ITEM #: 6.11	COMMITTEE OF ADJUSTMENT REPORT MINOR VARIANCE APPLICATION A153/22 41 Regency View Heights, Maple
---------------------	---

COMMITTEE OF ADJUSTMENT REPORT
MINOR VARIANCE APPLICATION
A153/22
41 Regency View Heights, Maple

To: Committee of Adjustment
From: Bernd Paessler, Building Standards Department
Date: June 15, 2022
Applicant: Suvina Nayyar
Location: PLAN 65M3556 Lot 209 municipally known as 41 Regency View Heights
File No.(s): A153/22

SITE PLAN

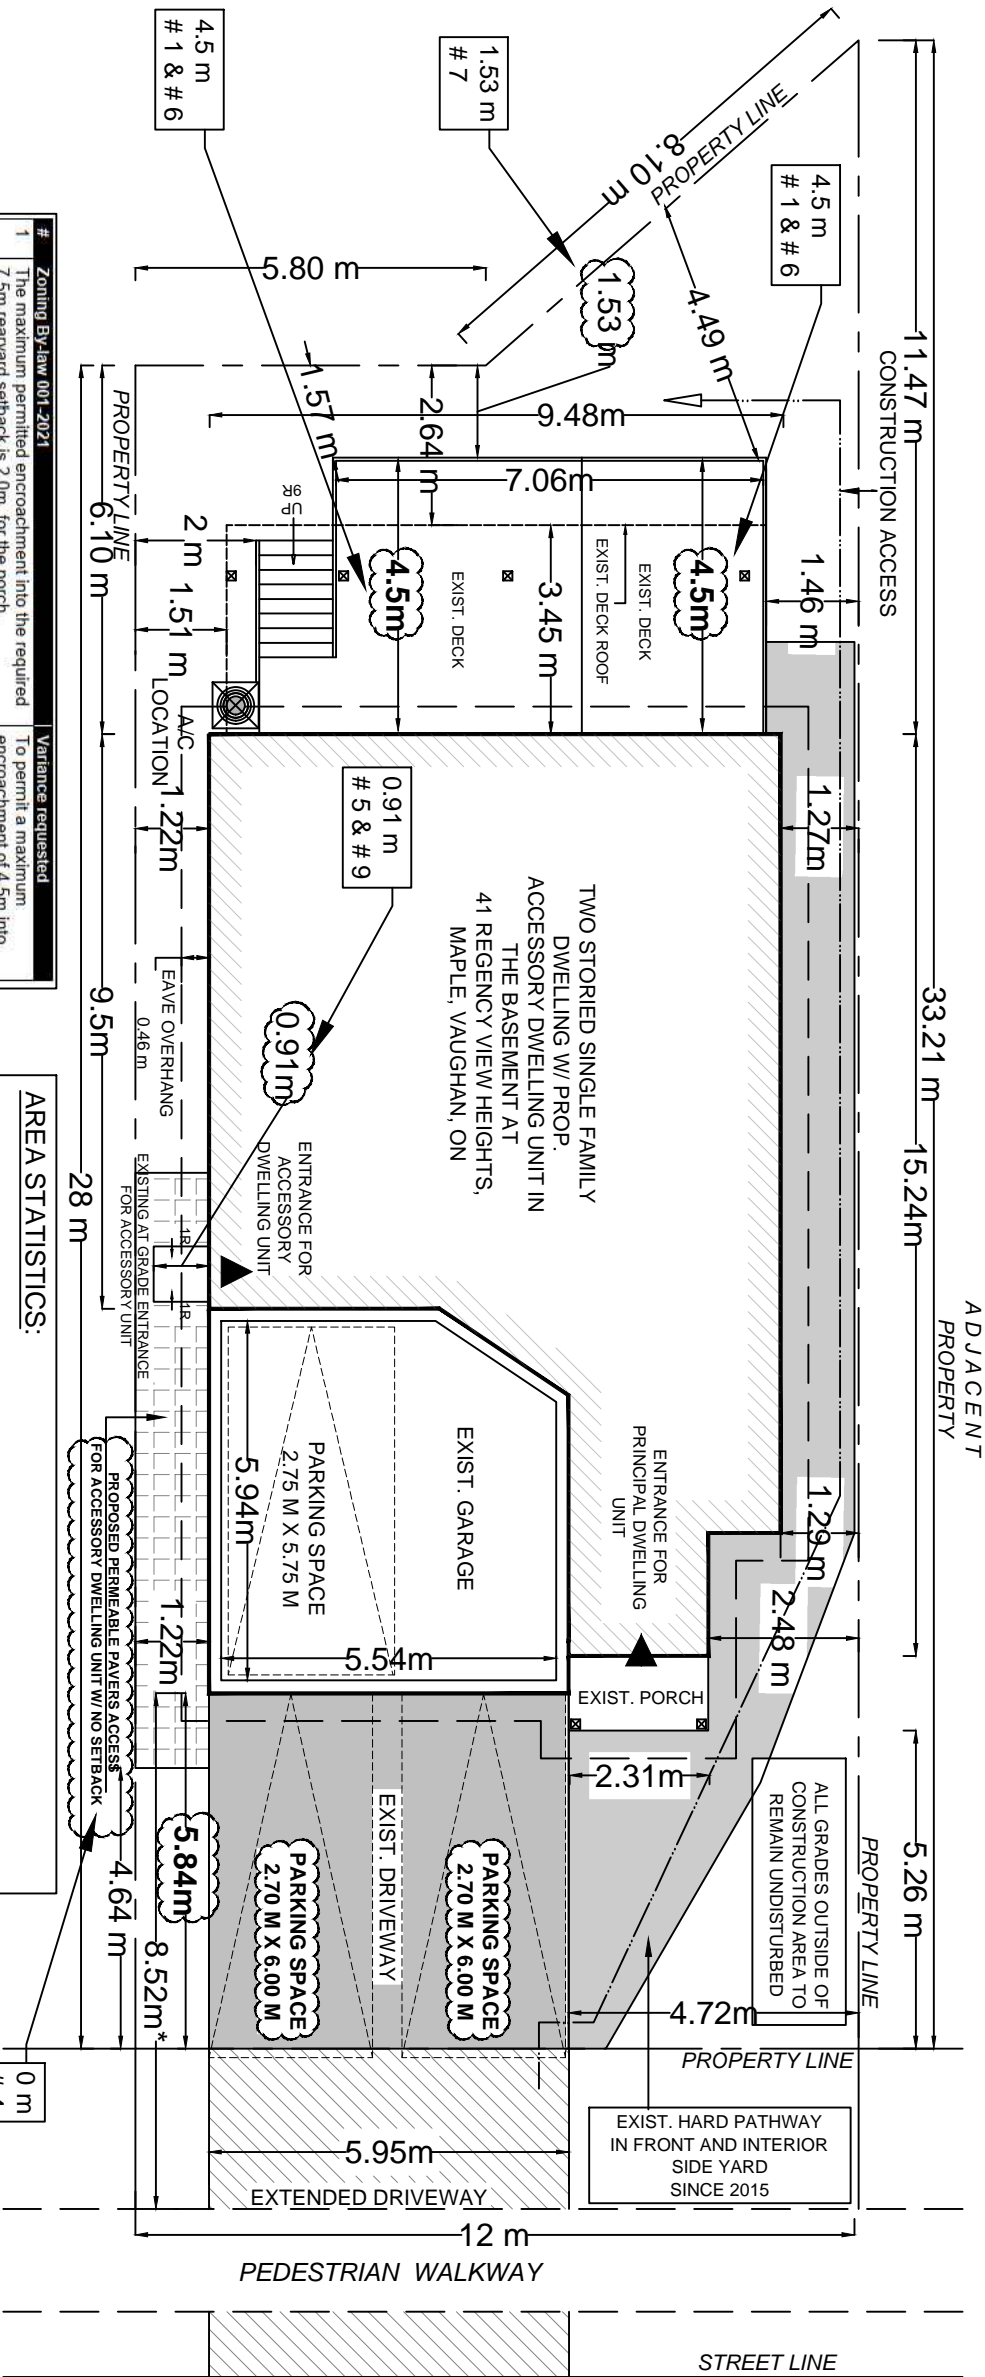
The Owner is requesting to permit a rear deck, a portion which is covered, a reduction in the soft landscaping within the front yard, walkways within each interior side yard, and a platform to access a side door with the above noted variances. The deck, inclusive of the covered portion, south side yard pathway, and front yard hardscaping are existing.

The Development Planning Department has no objection to Variances 1, 5, 6, 7, and 9, as the encroachment of the deck into the rear yard and the access stairs into the interior side yard maintains an appropriate area for access and drainage, will not have adverse

impacts to the neighbouring properties, nor impact the function of the abutting uses. Further to Variances 5 and 9, the proposed platform within the north side yard would have 1 riser on the east and west sides. The platform would provide access to a door slightly above grade. The door is proposed to be an entrance for a Secondary Suite. The modest height of the platform and the risers on each side ensure access between the front and rear yards is maintained.

The existing dwelling, covered front porch along with their eaves have a lot coverage of 49.41%. The rear covered deck, inclusive of eaves, adds an additional 8.83%, resulting in a total lot coverage of 58.24%. The maximum lot coverage is increasing not just because of the rear covered deck, but because the area underneath the eaves is, as of the writing of these comments, part of the lot coverage calculation in By-law 001-2021. The Development Planning Department recognizes that without the inclusion of the eaves, the existing dwelling along with the rear covered deck would have a total lot coverage that complies with By-law 1-88 and 001-2021. The lot coverage is consistent with previous approvals in the City, is 3.24% more than the current requirement, and will not pose a significant visual impact to the surrounding properties or streetscape. The increase in total lot coverage is minor in nature and as such, the Development Planning Department has no objection to Variance 2.

The Development Planning Department is not in the position to support Variances 3 and 8 for the reduction of front yard soft landscaping as the additional concrete located on either side of the driveway in the form of walkways and parking surfaces. The soft landscaping reduction provides an uninterrupted length of hardscaping which, save for the triangular strip of soft landscaping to the side and in-front of the front and the south side yard walkways respectively, runs from one side lot line to the other. The degree of hardscaping proposed gives off the perception of a driveway much wider than the two car garage it serves. This degree of hardscaping is not in keeping with the intent of the By-laws nor the soft landscaping established by other properties along the street. The 11.83% deficiency in front yard soft landscaping is not considered minor in nature and visually impacts the streetscape.

The Development Planning Department has no objection to Variance 4. The relief for the proposed hard landscape walkway is confined to the south interior side yard. The walkway facilitates access between the front and rear yards. The southern walkway leading to the Secondary Suite will consist of permeable pavers, which the Development Engineering Department has reviewed and is satisfied that drainage along the side yard will be maintained. Development Engineering has also confirmed that they have received a signed letter from the neighbour to the north stating that they have not experienced any ponding issues caused by the northern walkway.

Accordingly, the Development Planning Department cannot support Variances 3 and 8 and is of the opinion that the proposal is not minor in nature and is not desirable for the appropriate development of the land.

The Development Planning Department can support Variances 1-2, 4-7, and 9 and are of the opinion that the proposals are minor in nature, maintains the general intent and purpose of the Official Plan and Zoning By-laws, and is desirable for the appropriate development of the land.

The Development Planning Department recommends **refusal** of Variances 3 and 8, and **approval** of Variances 1-2, 4-7, and 9.
